## Work Changes Proposal Request

**PROJECT** (Name and address):  
GENERAL SERVICES BUILDING  
ROOF REPLACEMENT  
1555 OLD FRANKFORT PIKE  
LEXINGTON, KY 40504

**PROPOSAL REQUEST NUMBER:** 002

**SUPPLEMENTAL DRAWINGS ADDED 12.28.16**

**1 ROOF PLAN**  
SCALE: 1/8" = 1'-0"

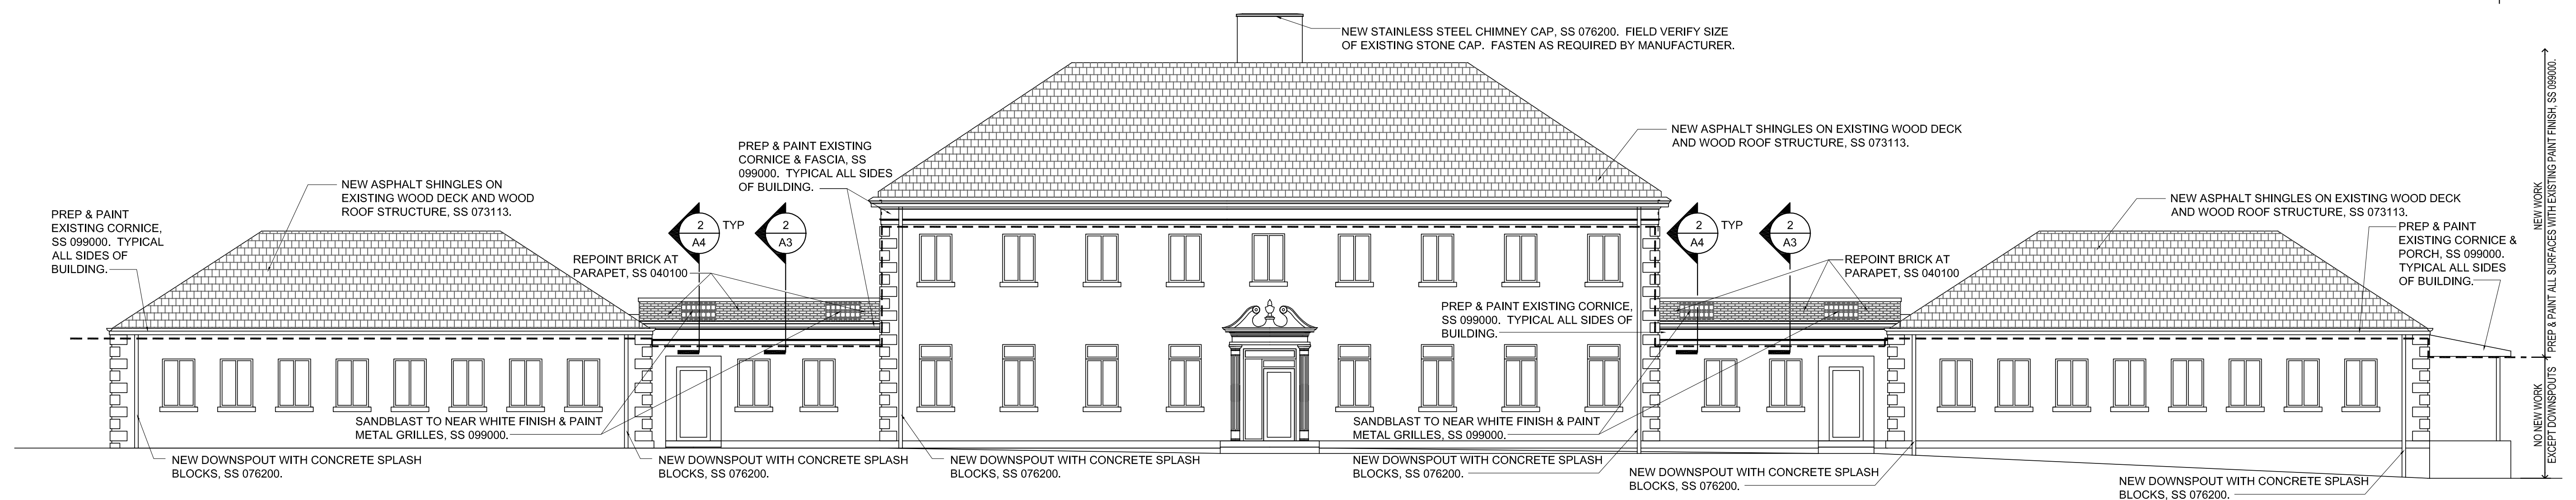
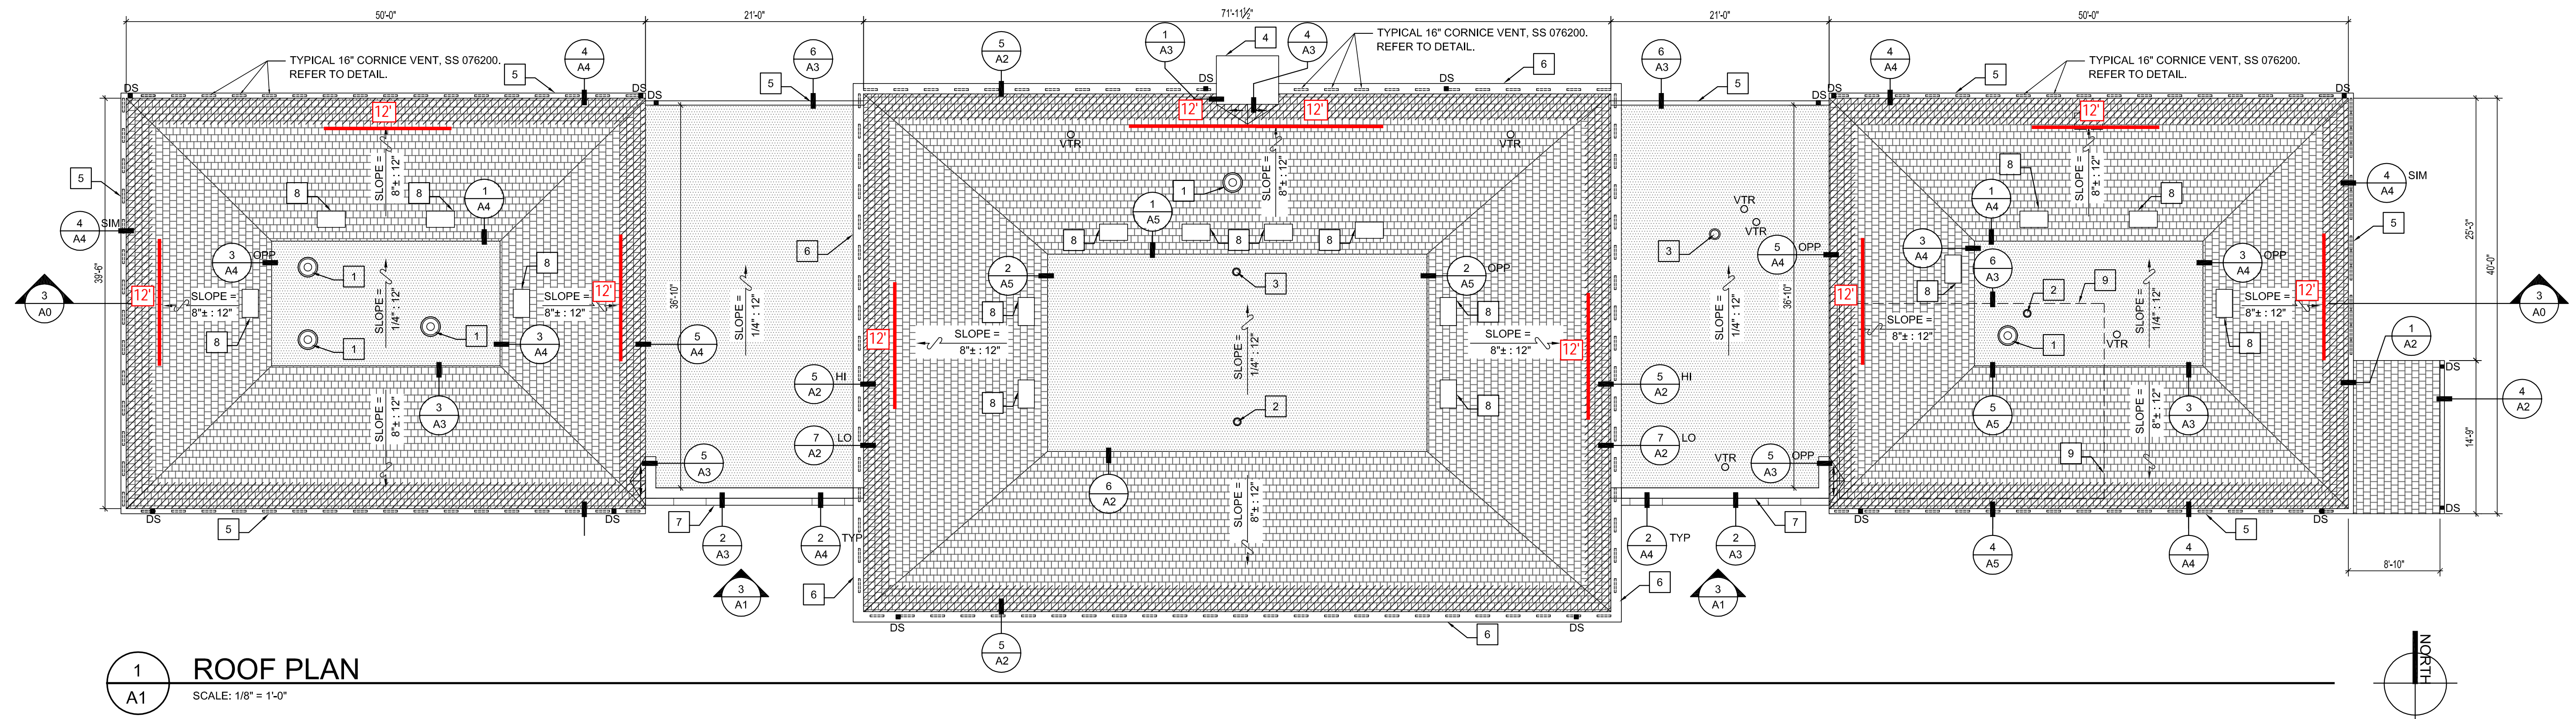
Provide a breakdown of material cost and labor to install ten 12'-0" lengths (120'-0" feet total) of the 24 gage Metal Era Dual Vents and eighteen end caps. The vents shall be located in conformance with the attached plan and installation details. The 2" cut in the roof deck shall occur 3'-6" from the roof eave. Provide intermediate wood support at the cut ends of the roof deck as required.

Provide labor credit for eliminating the cuts to the soffit boards at Areas A, B & C.

Provide labor credit for eliminating the modification of the decorative 1x10 trim board in Area C.

PROPOSAL REQUEST #2  
 SUPPLEMENTAL DRAWING #1  
 DECEMBER 28, 2016

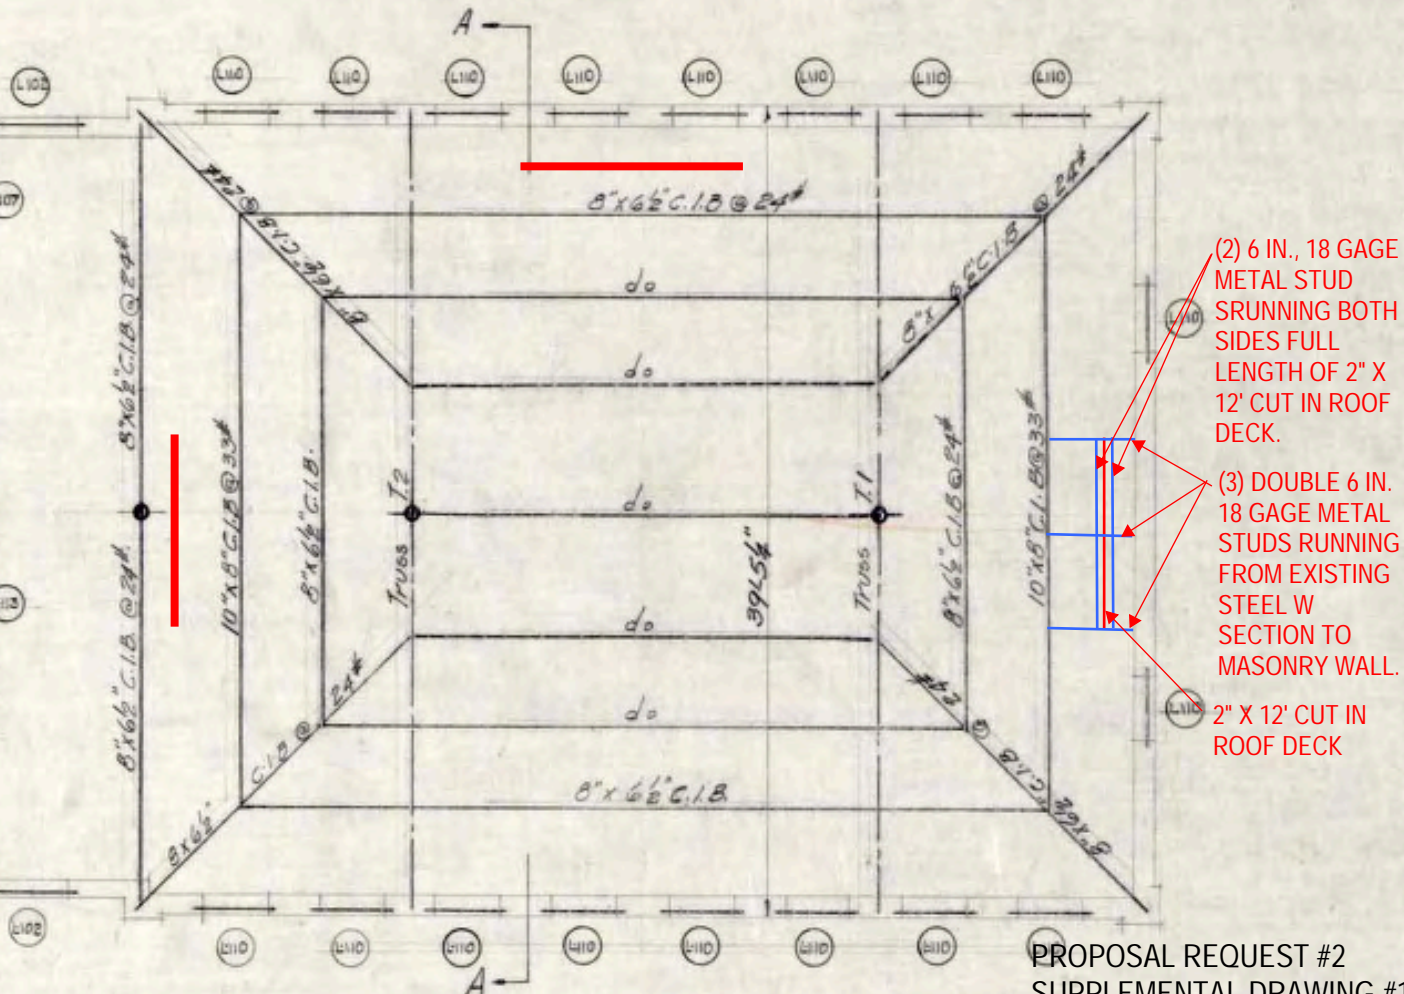
- (2) 6 IN., 18 GAGE METAL STUD RUNNING BOTH SIDES FULL LENGTH OF 2" X 12' CUT IN ROOF DECK.
- (3) DOUBLE 6 IN. 18 GAGE METAL STUDS RUNNING FROM EXISTING STEEL W SECTION TO MASONRY WALL.
- 2" X 12' CUT IN ROOF DECK

## PARTIAL SECTION AT INTAKE VENT

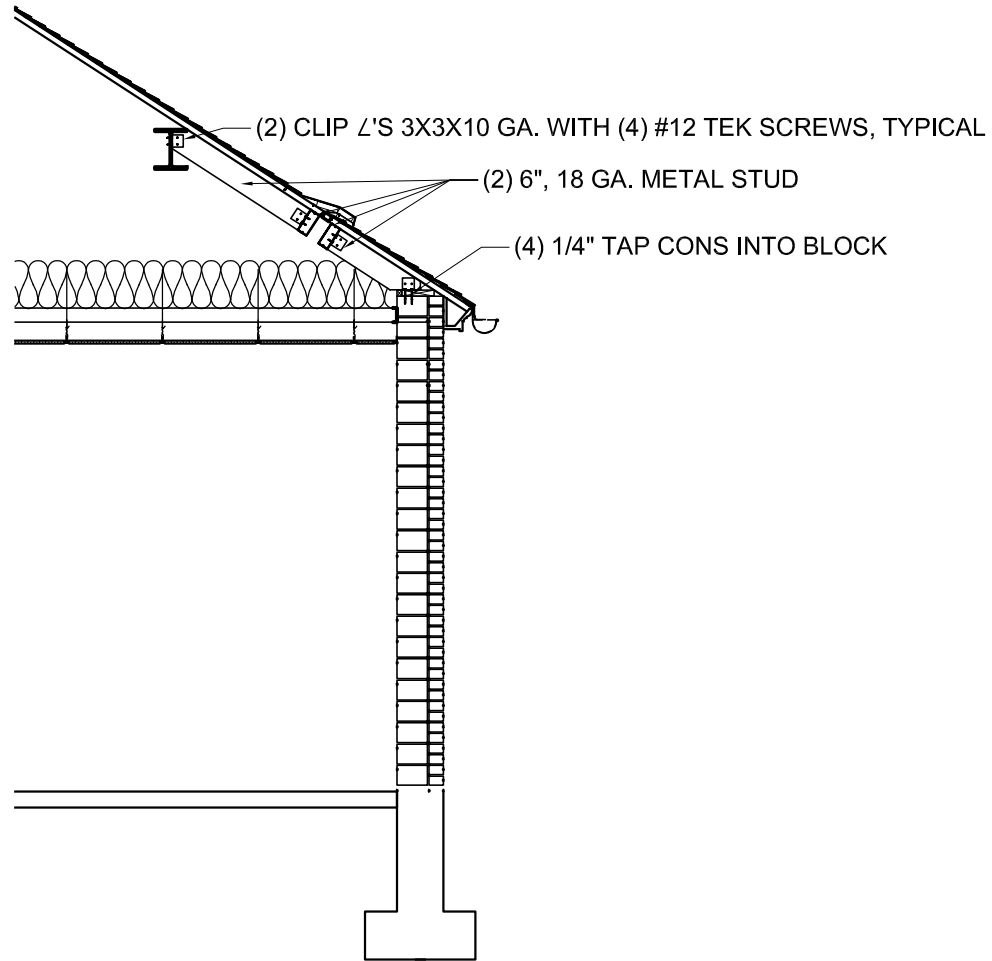
PROVIDE INTERMEDIATE SUPPORT AT CUT ENDS  
OF EXISTING ROOF DECK AS REQUIRED.

PROVIDE 12'-0" LONG X 2"  
CUT IN EXISTING ROOF  
DECK PER DUAL VENT.

~~OSB OR  
PLYWOOD~~  
EXISTING 1X  
ROOF DECK
